**Re: Comments on Ongoing Work to Satisfy the Red Hill Bulk Fuel Storage Facility
("Facility") Administrative Order on Consent ("AOC") Statement of Work
requirements 7.1.3 (Groundwater Flow Model Report) and 7.2.3 (Contaminant Fate
and Transport Report).**

Subject: Comments on the State of the Conceptual Site Model and Related Evaluations for the Navy
Red Hill Tank Farm Facility, Pearl City, Hawai'i

Subject: Comments on Presentation Materials from the Red Hill Groundwater Modeling Working Group (GWMWG) Meeting #7 and Status of Interim Modeling as Presented Associated with Administrative Order on Consent ("AOC") Statement of Work Requirements 7.1.3 (Groundwater Flow Model Report) and 7.2.3 (Contaminant Fate and Transport Report)

RE: **Comments on the Progress of the Red Hill Groundwater Flow Model**

RHMW01

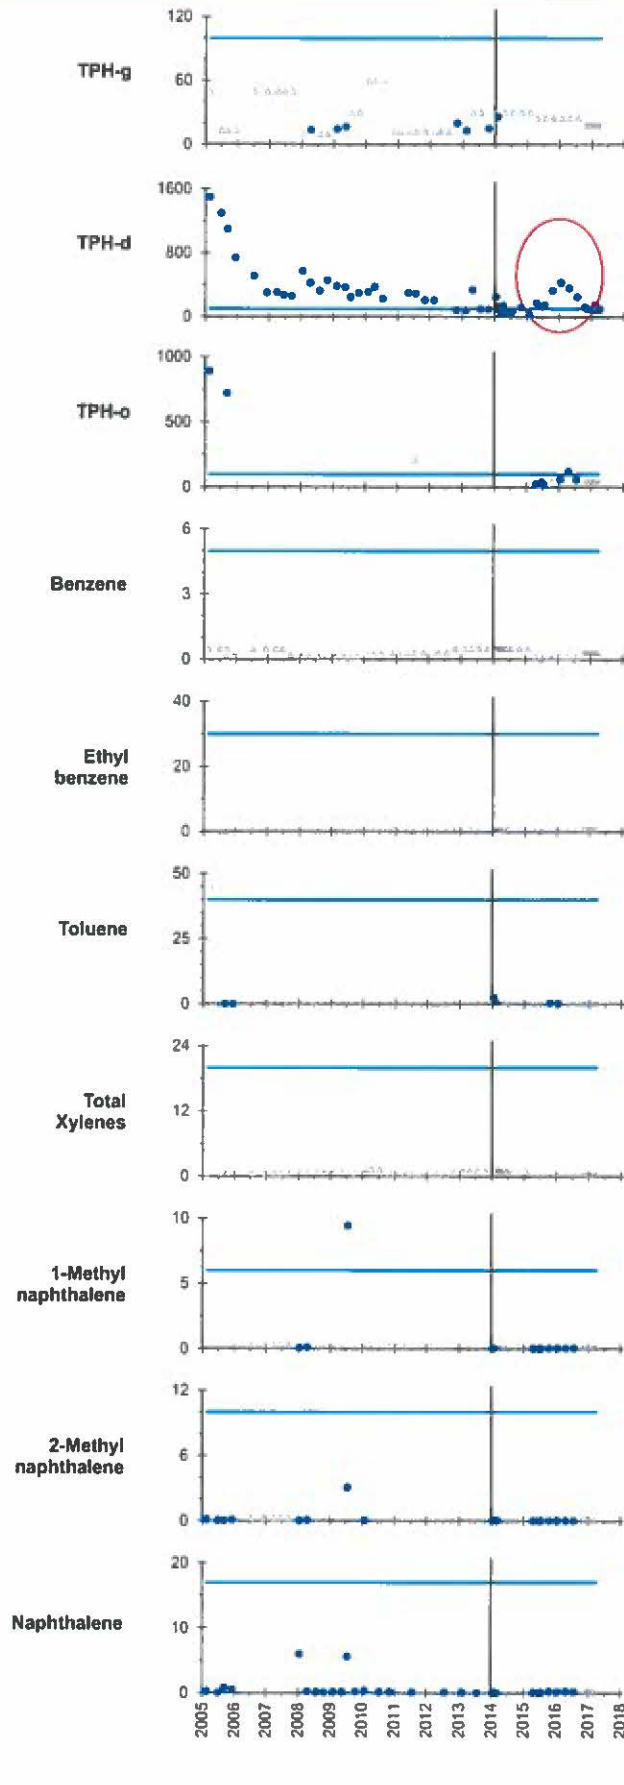
- The 2014 release likely impacted groundwater as evidenced by concentration trend increases in some wells following the release (e.g., RHMW01, RHMW02, RHMW03; attached). This is also consistent with associated sharp increases in soil vapor concentrations following the 2014 release (attached, slide deck pg. 21).
- Generally elevated and persistent dissolved-phase concentrations at RHMW02 indicate the presence of jet fuel impacts to groundwater over the full period of monitoring (i.e., jet fuel is in contact with groundwater somewhere in the vicinity).
- Periodic low-level dissolved-phase impacts at the Red Hill Shaft monitoring well suggest distal transport from the tank farm has potentially occurred, supporting the possibility of

Detections increased, scale does not allow trend observation.

RHMW02

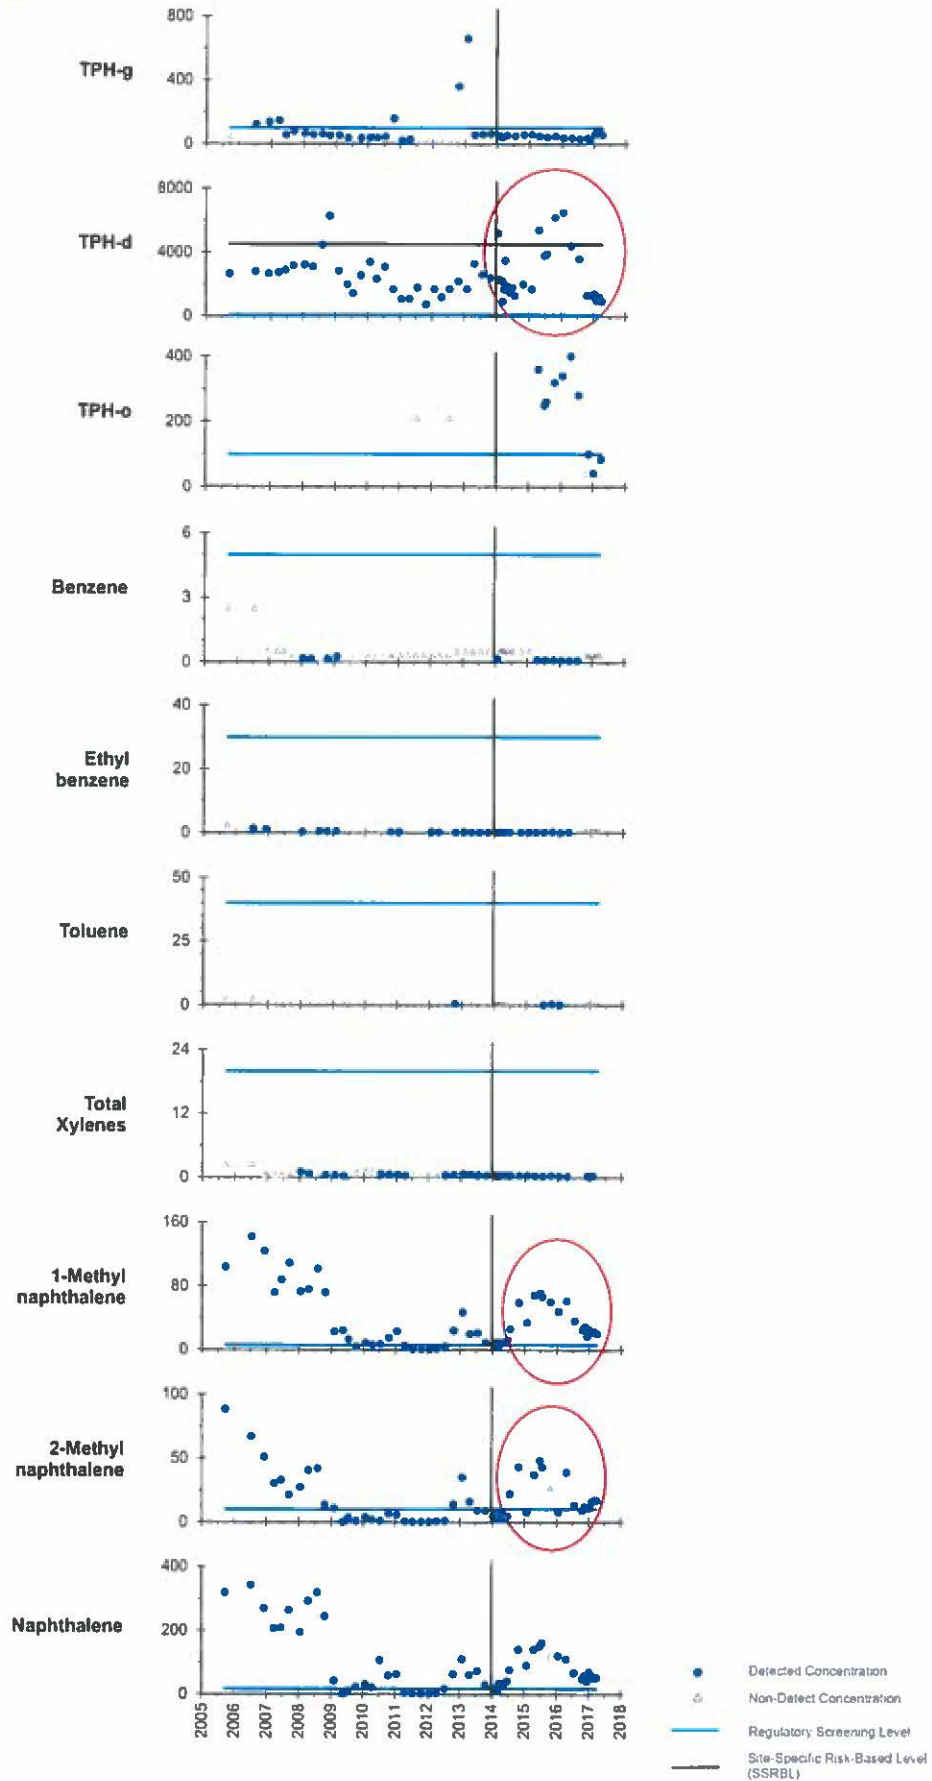
Detections increased, scale does not allow trend observation.

Figure 1. A comparison of the simulated and measured groundwater elevations in the RHMNW. RHMW07 is excluded from this graph since the water level in this well is very anomalous. The Red Hill Shaft (2254-01) is also excluded due to questions about the top of casing reference

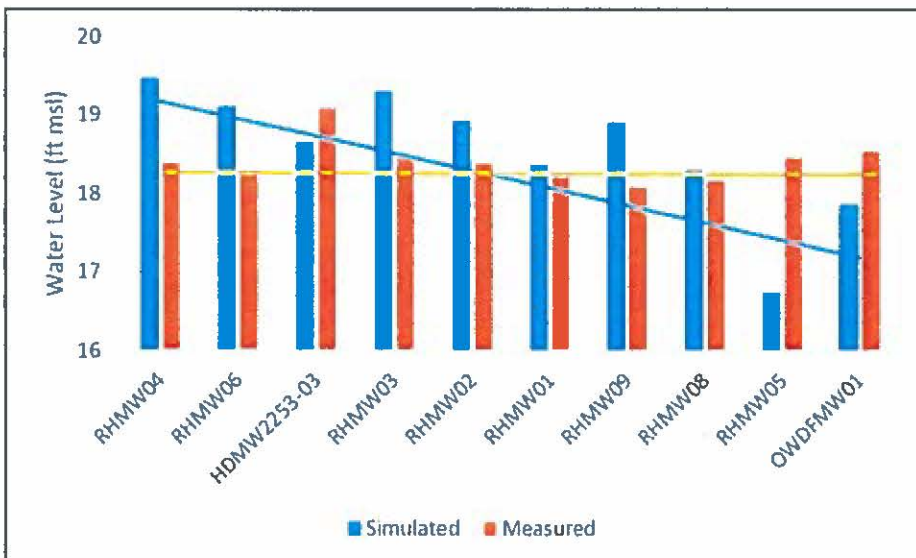
The model results presented in the February 12th Red Hill Groundwater Modeling Working Group (RHGWMWG) meeting show groundwater elevation patterns much different from those measured. For example Slide 24 from the February 12 RHGWMWG meetings shows that the simulated water level near RHMW05 is about a foot lower than that at RHMW02, much different than what is measured. In fact this infers a gradient of more than 3 feet per mile, rather than the flat gradient that is consistently measured. More importantly, for the Red Hill Shaft zone of contribution shown in Slide 57 to be valid the relative groundwater elevations simulated by the model within that zone of contribution should be in close agreement to those measured in the field.

The bar graph below compares the modeled groundwater elevations (blue bars) to those measured in 2017 (orange bars). The data are arranged going from RHMW04, the most upslope well, to OWDFMW01, the most down slope well. A visually estimated trend line is drawn for each data set. The values for the modeled groundwater elevations were derived by applying the modeled residuals in Slide 30 to the average of water level measurements during the July and November rounds of groundwater sampling. For the modeled capture zone shown on Slide 57 to be valid there should reasonable agreement between the trend in the modeled and measured groundwater elevations. Clearly this is not the case, and the presented model is essentially no better than that of Rotzoll and El-Kadi the Red Hill investigation is tasked to improve upon.

If the zone of contribution for the Red Hill Shaft is in error, then likely that for the Halawa Shaft is also in error. Also, the data need to be presented in such a way that reviewers can easily determine whether or not the conditions for model validity are met. The calibration graph shown in Slide 26 does not provide sufficient information to allow an assessment of model validity. It also appears that wells on the extreme greatly improve the appearance of correlation between the simulated and measured water levels but may not appropriate for this purpose.

In summary, for the groundwater flow model to be acceptable as a risk assessment tool, there must be much better agreement between the simulated and measured water levels in the critical areas. These areas are the Moanalua area wells, the RHMNW wells, and the wells in the Halawa area.
